HUNTER'S COVE SUBDIVISION

APPLICATION NUMBER 13 DATE June 17, 2004

REQUEST Subdivision

DETAIL SITE PLAN

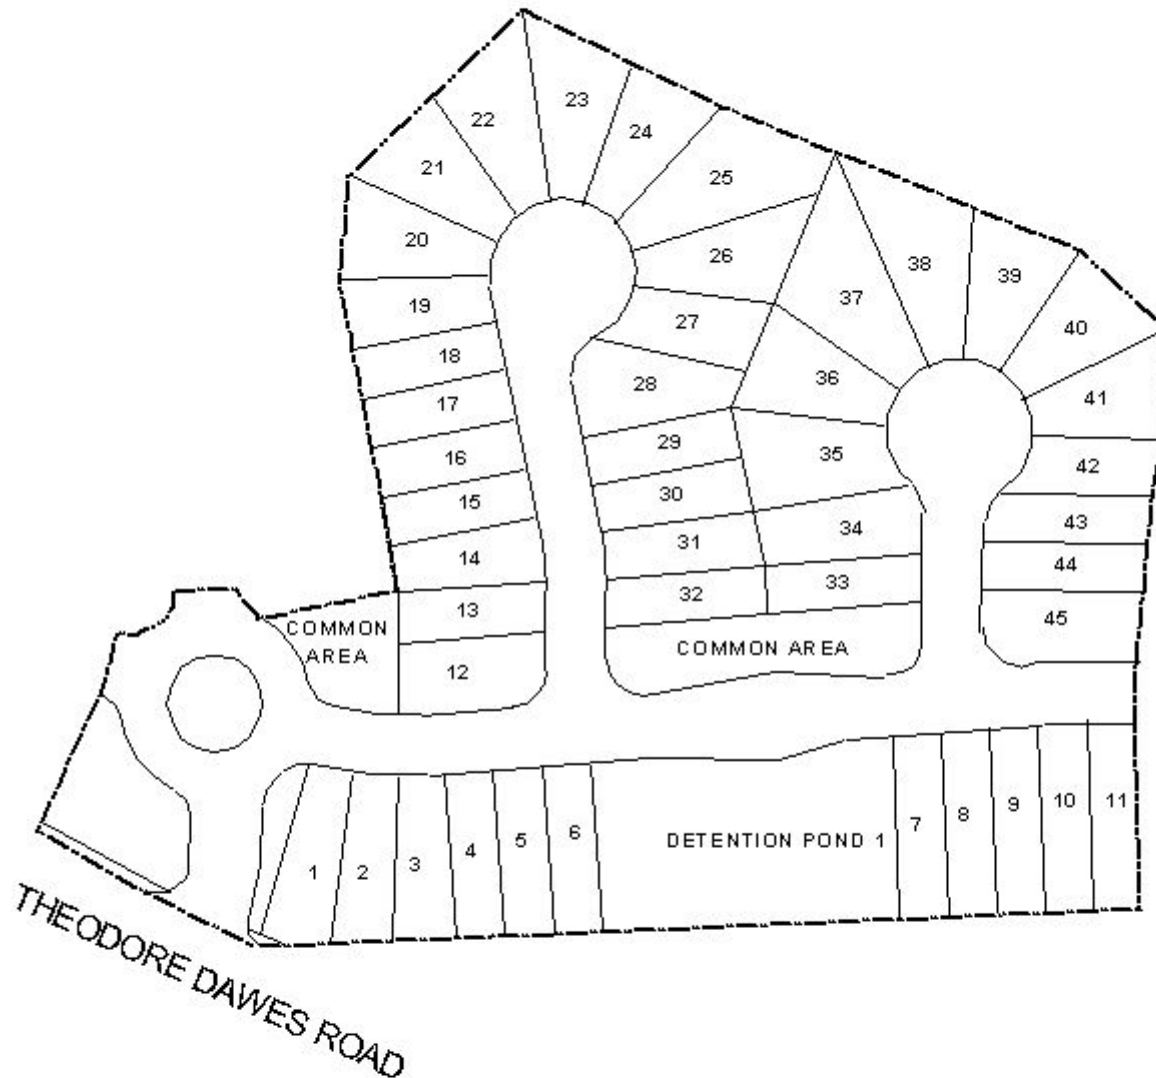
The plat illustrates the proposed 367-lot, 135.0± acre subdivision which is located on the North side of Theodore Dawes Road at the North terminus of Leythan Drive, extending North to the West termini of Cheyenne Street and Hooper Street, and East to the South termini of Huron Road and Mackenzie Drive. The subdivision is served by city water and sanitary sewer facilities.

The purpose of this application is to create a 367-lot phased development providing a variety of housing options and as such may be considered innovative. Included in this report are detail site plans illustrating the master plan and the individual plats for the four separate units: 40-foot lots, 60-foot lots, 60 and 80-foot lots, and 90-foot lots. Additionally, a similar application was approved by the Commission in December 2002 as a 373-lot phased development. While in the process of development the developer failed to apply to the Commission for an extension, and the approval expired. The applicant has now resubmitted the subdivision application to the Commission.

Another issue to consider is that of access to the development. With the exception of the southern terminus of Huron Road, the development will connect with the existing street stubs. The connection with the southern terminus of Huron Road is not necessary, as there is adequate connectivity in the area; however, there are concerns regarding access to Theodore Dawes Road. This subdivision consists of 367 lots, and the only new point of access is proposed; the connections with the existing street stubs will ultimately net two additional points of access to a Major Street (Three Notch Road). The existing subdivision to the North has 97 lots, and upon completion of this subdivision, 464 total lots will have only three points of access. The previous application submitted to the Commission did not illustrate a second access point to the development from Theodore Dawes Road; however, after discussion on this project the applicant agreed to the construction of a deceleration lane and left turn lane for east bound traffic on Theodore Dawes Road. The applicant also offered traffic calming devices during the initial application to further enhance safe vehicular patterns, which should be coordinated with and approved by County Engineering and Urban Development Department.

With a waiver of Section V.D.2. modifications, the plat will meet the minimum requirements of the Subdivision Regulations and is recommended for Tentative Approval subject to the following conditions: 1) dedication of the necessary right-of-way to provide 50-feet from the centerline of Theodore Dawes Road, a planned major street; 2) the placement of a note on the final plat stating that direct access to Dawes Road is denied for Lots 1-4 of Unit Three and Lot 1 of Unit One, Phase One; 3) the placement of a note on the final plat stating that the maintenance of all common areas shall be the responsibility of the property owners; 4) the construction of a deceleration lane and left turn lane for east bound traffic on Theodore Dawes Road as previously offered by the applicant; 5) the provision of traffic calming devices as offered by the applicant, to be coordinated with and approved by County Engineering and Urban Development Department; and 6) the placement of a note on the final plat stating that a buffer, in compliance with Section V.A.7., will be provided where the site adjoins residentially developed property.

HUNTER'S COVE SUBDIVISION UNIT THREE

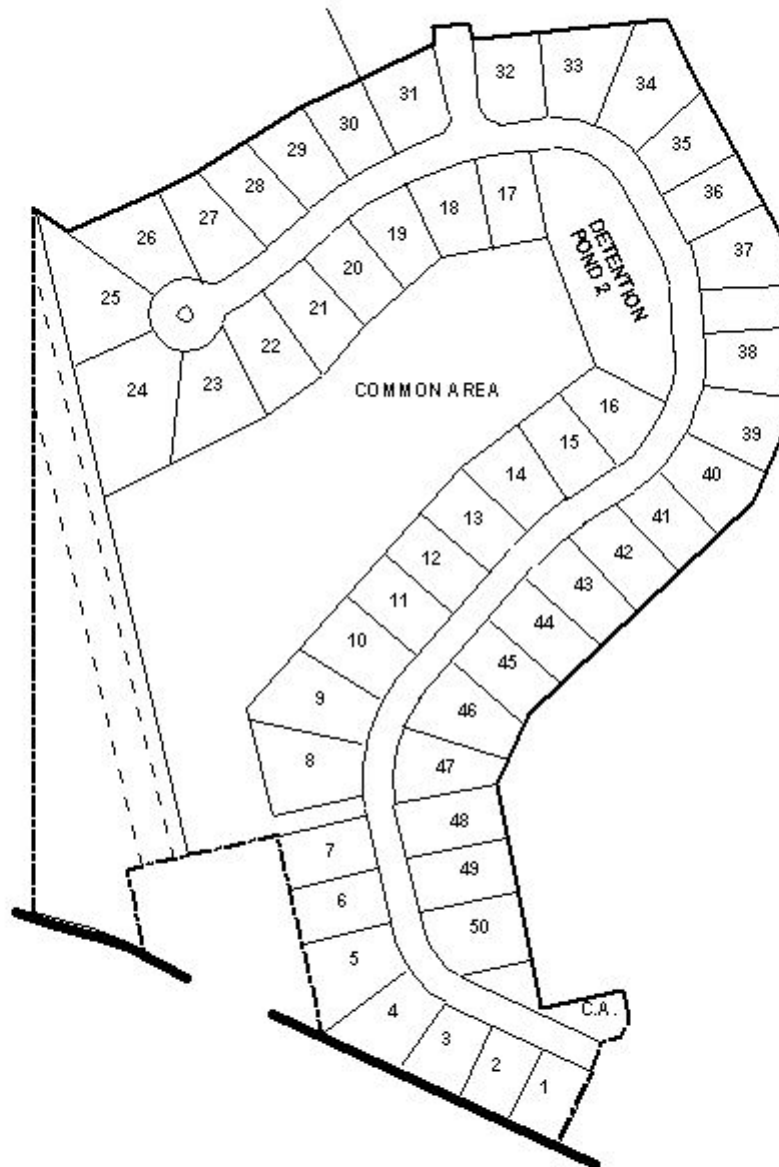
The site fronts Theodore Dawes Road, a planned major street which is illustrated on the Major Street Plan, and has an existing right-of-way of 80-feet, thus the dedication of sufficient right-of-way to provide 50-feet from the centerline would be required. Additionally, as a means of access management, a note should be placed on the final plat stating that Lots 1-4 of Unit Three, and Lot 1 of the Unit One, Phase One are denied direct access to Theodore Dawes Road.
